RE: South West Slopes Fire Control Centre and Regional Office - Harden NSW

In response to the Hilltops Council request for additional information dated 02/02/18 we have reviewed items 2 & 3 with our findings and comments detailed below.

PRELIMINARY TREATMENT TRAIN

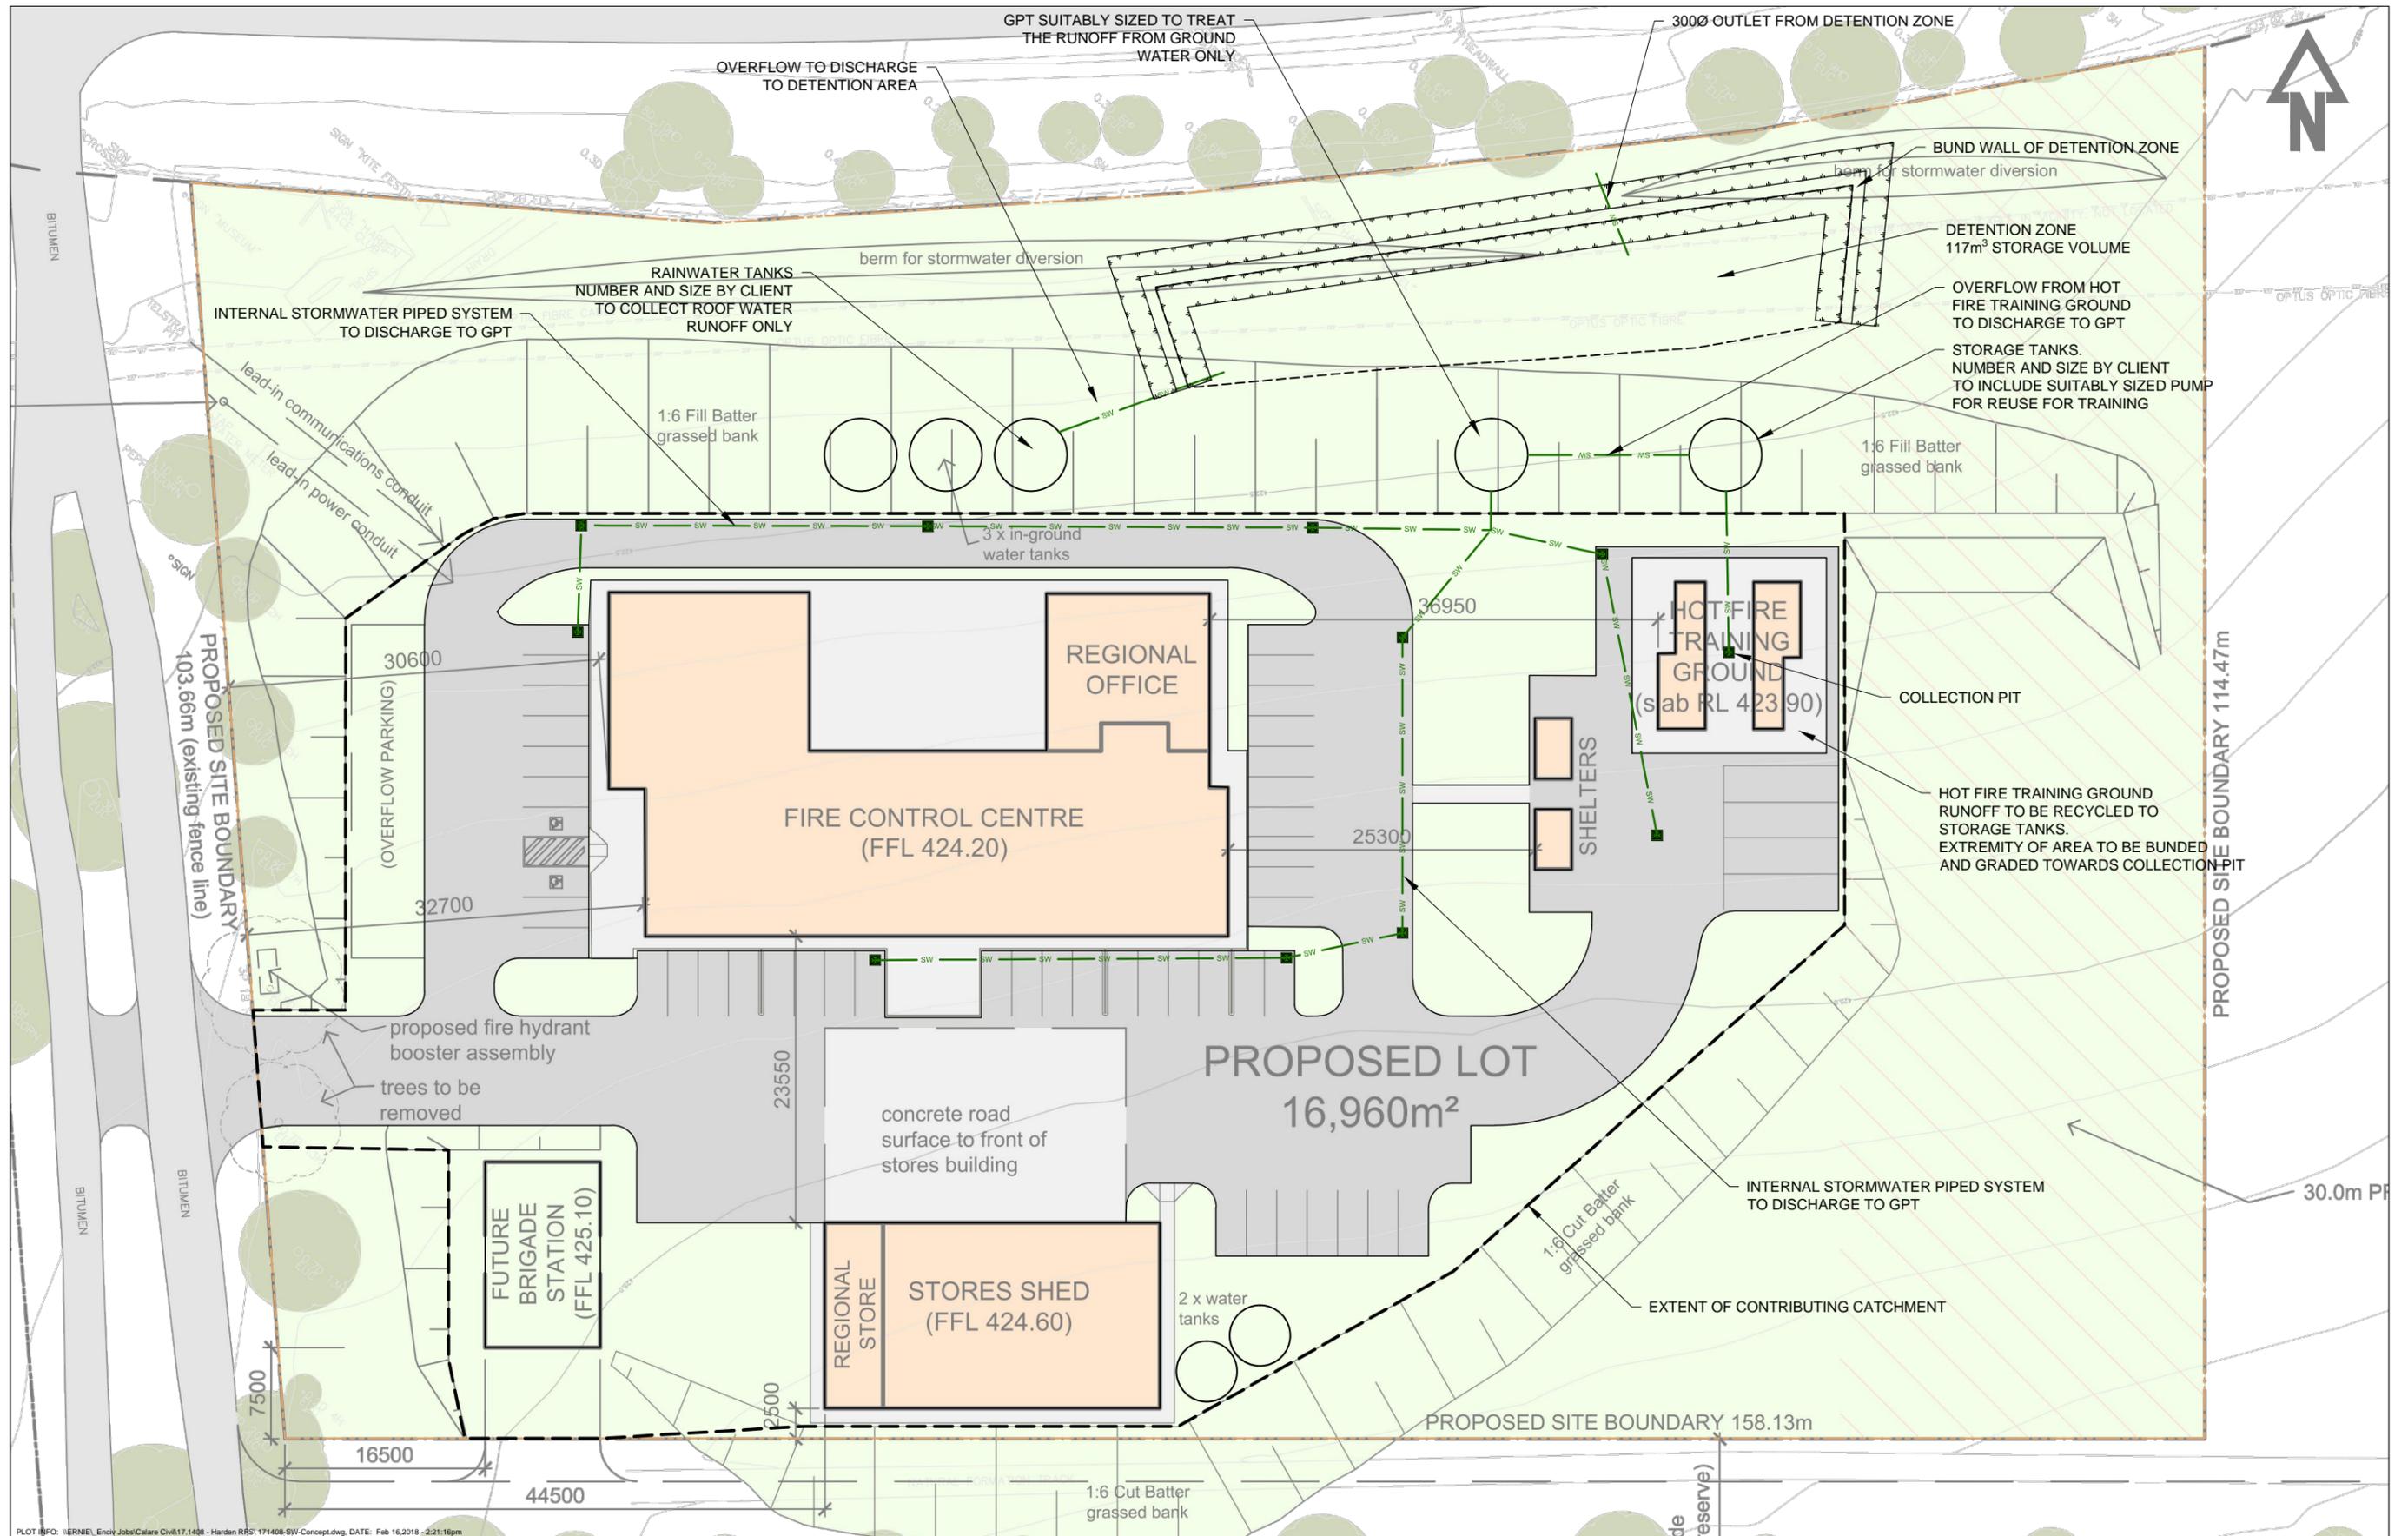
Item 2
Stormwater Management

Impact on Groundwater

The main concern for this development is identified as being the possibility of hydrocarbons, oils & sediment from the carpark areas and the possibility of chemicals from the hot fire training area impacting the ground water.

We have reviewed the proposed development design and offer a preliminary layout (attached) for an effective stormwater network onsite. This network will be setup in three parts.

1. One system will capture the various roof areas and direct the runoff to rainwater tanks for onsite reuse. The actual estimated usage is to be determined in conjunction with a hydraulic consultant. The overflow from these tanks is to be directed to the detention zone.

2. The ground water for the site, excluding the hot fire training ground, is to drain to a piped network which will discharge via a GPT to an above ground detention zone.

- a. The GPT is to be sized to be able to satisfactorily treat the ground level hardstand area for sediment, oils and hydrocarbons.
 - b. A preliminary catchment analysis indicates that the contributing catchment for the development area of the site only is in the region of 0.8120ha with a fraction impervious of 0.74. The predeveloped flow is in the region of 0.093m³/s for the 10% AEP event and 0.22m³/s for the 1% AEP event.
To ensure that the developed runoff does not exceed these values a detention zone is proposed to be constructed by way of a constructed bund, sized with a storage capacity of some 117m³. This will include controlled discharge via a 300 dia pipe to give a post development discharge flow of 0.090m³/s & 0.107m³/s for the 10% & 1 % AEP events respectively. This is below the current predeveloped flows

3. Council has noted that the culvert under the highway may have to be upgraded, if this is currently undersized that may be the case but through the use of the detention zone it is anticipated that this development will not increase the loading on this culvert and therefore may not require upgrading.

Through the use of a GPT that can treat oil, grit, sediment & hydrocarbons it is deemed that the carpark runoff will be satisfactorily treated.

For the hot fire training ground it is understood that firefighting foam is not going to be used so the anticipated pollutant runoff is minimised.

Regardless it is proposed to set up the training area to use recycled water from a rainwater tank that will drain back into the same storage tank, this will minimise the risk of pollutants entering the ground water.

The overflow from this tank will discharge via the GPT prior to discharging from site.

It is believed that by providing the above systems (GPT & Detention) that the impact on the downstream system will be minimised.

Full design details will be submitted to Council as part of the Construction Certificate application, included with this letter is a preliminary concept stormwater treatment train.
